Title: ZX81+38 Revision 1.10

Size: A2	Date: 2023-06-13	Rev: 1.10
KiCad E.D.A. kicad (6.0.1-0)		Id: 1/1

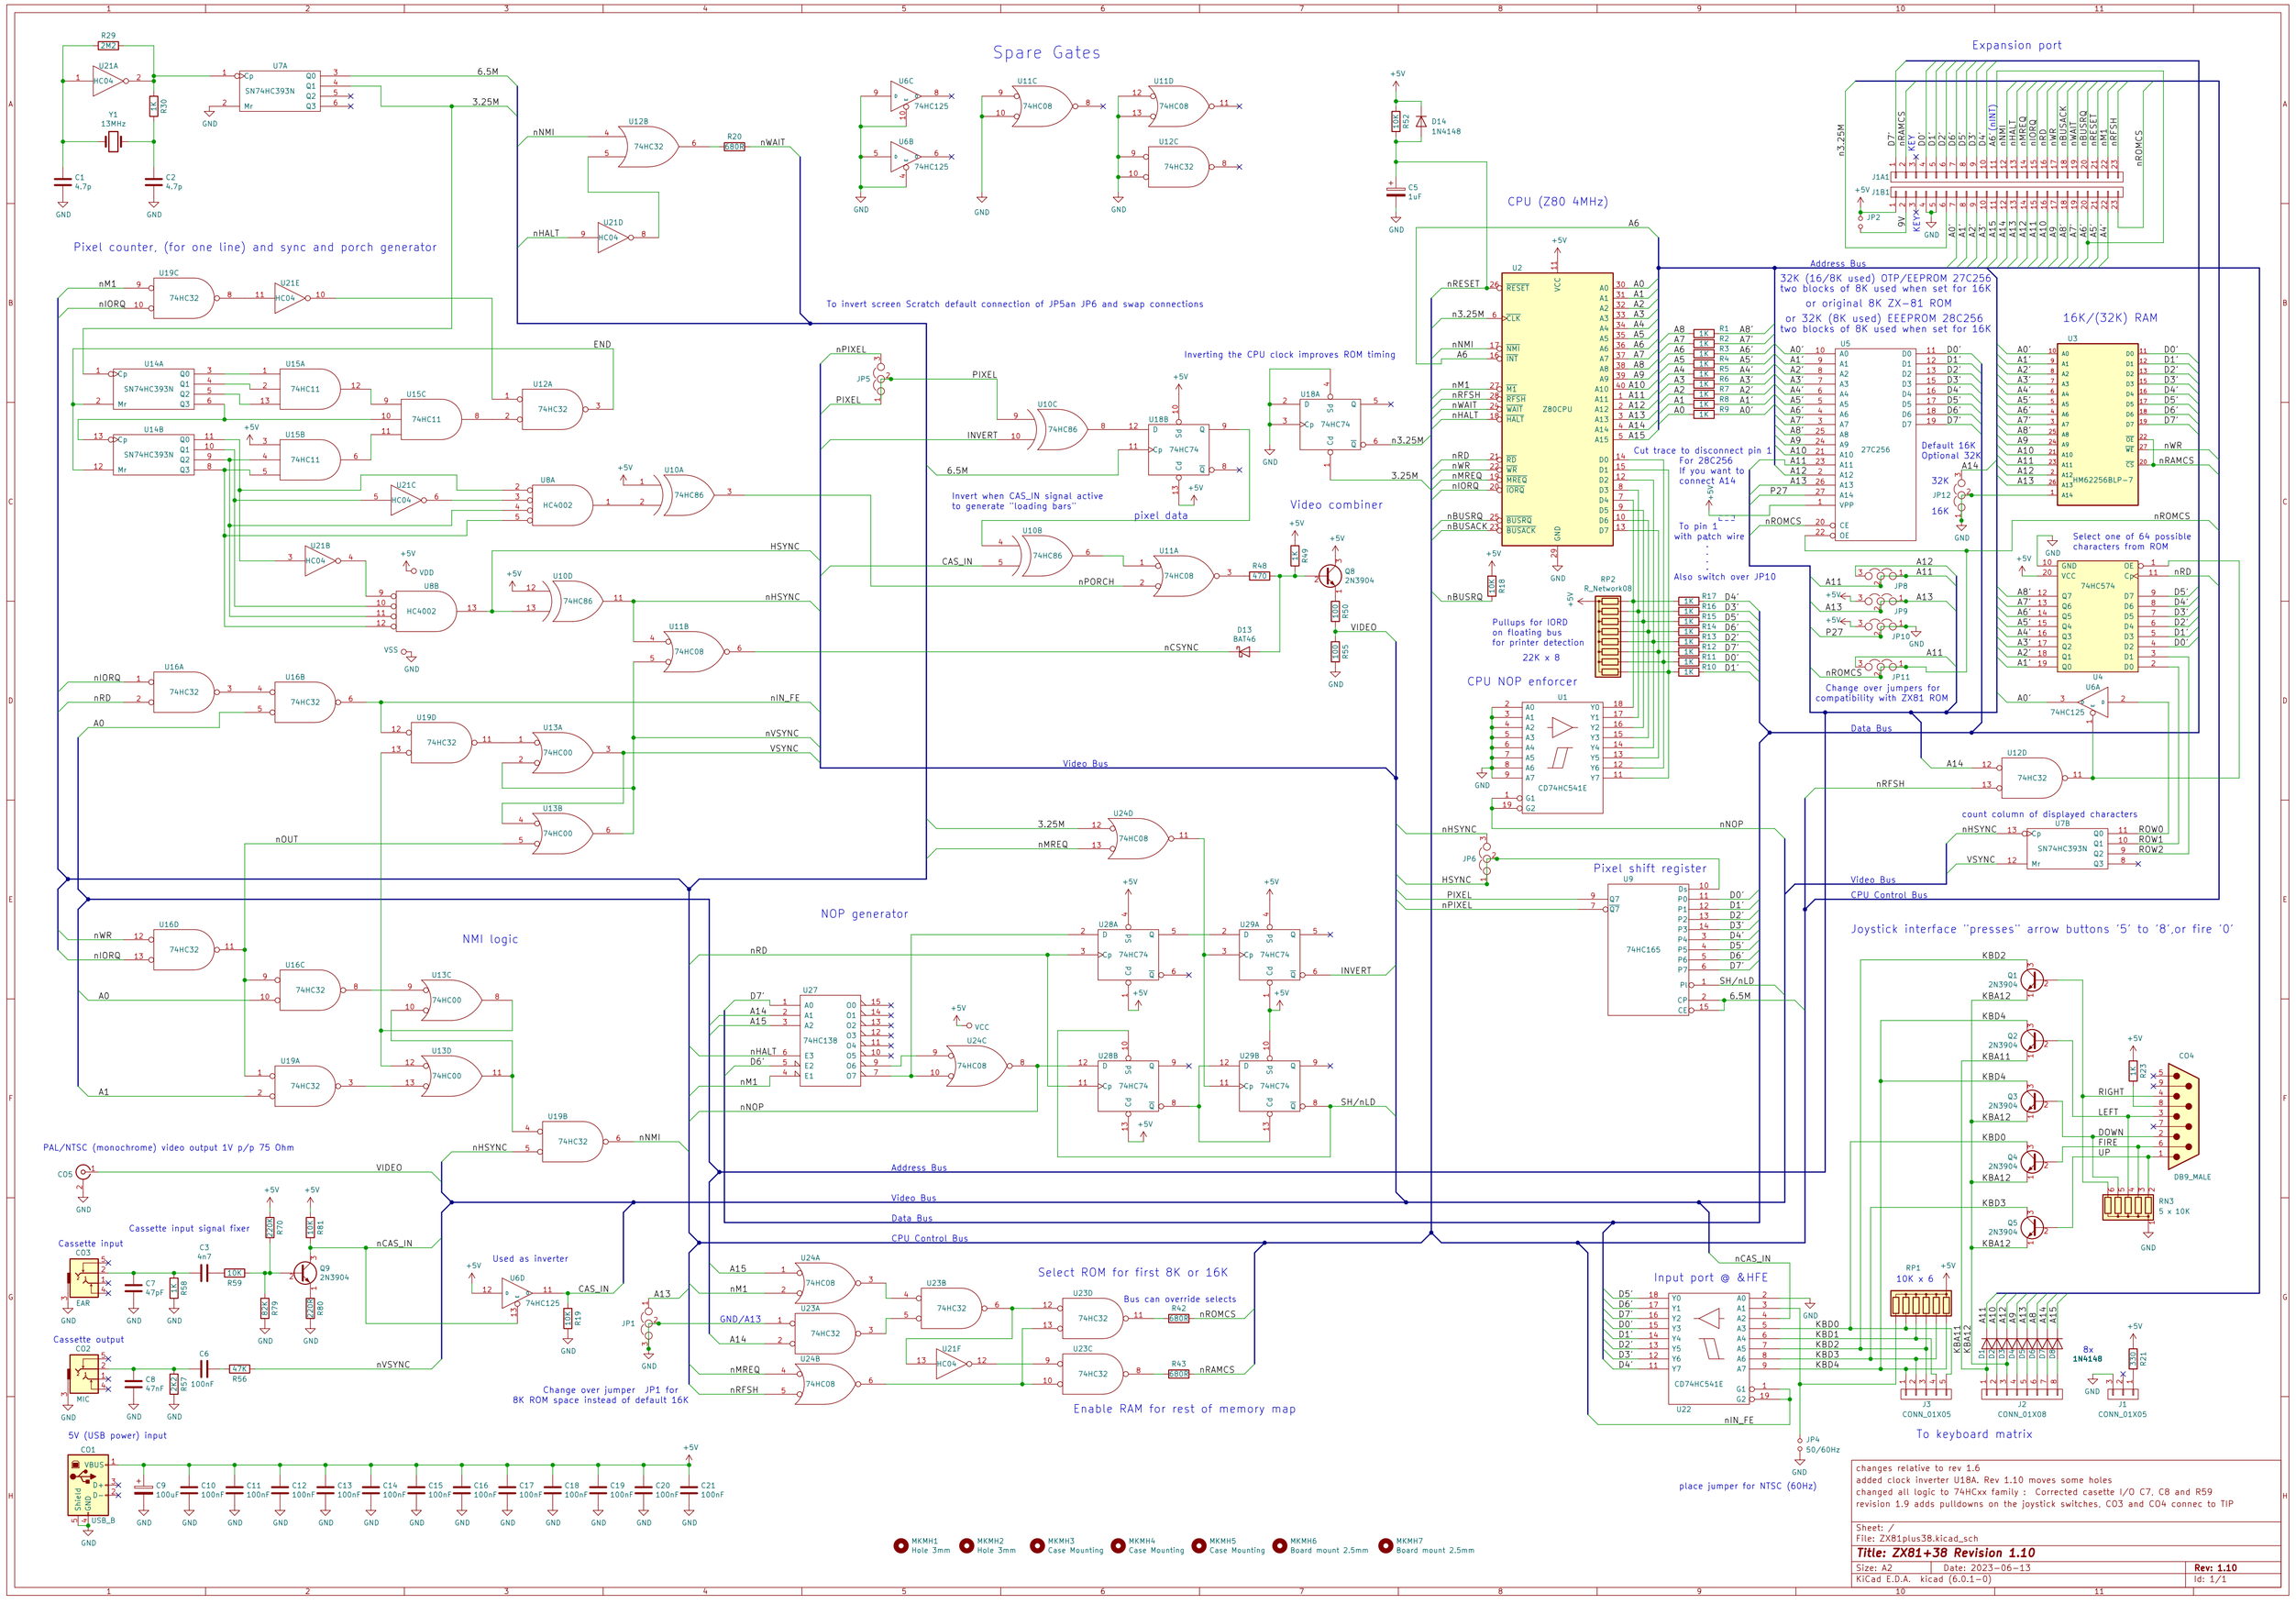
changes relative to rev 1.6
added clock inverter U18A. Rev 1.10 moves some holes
changed all logic to 74HCxx family : Corrected casette I/O C7, C8 and R59
revision 1.9 adds pulldowns on the joystick switches, CO3 and CO4 connec to TIP
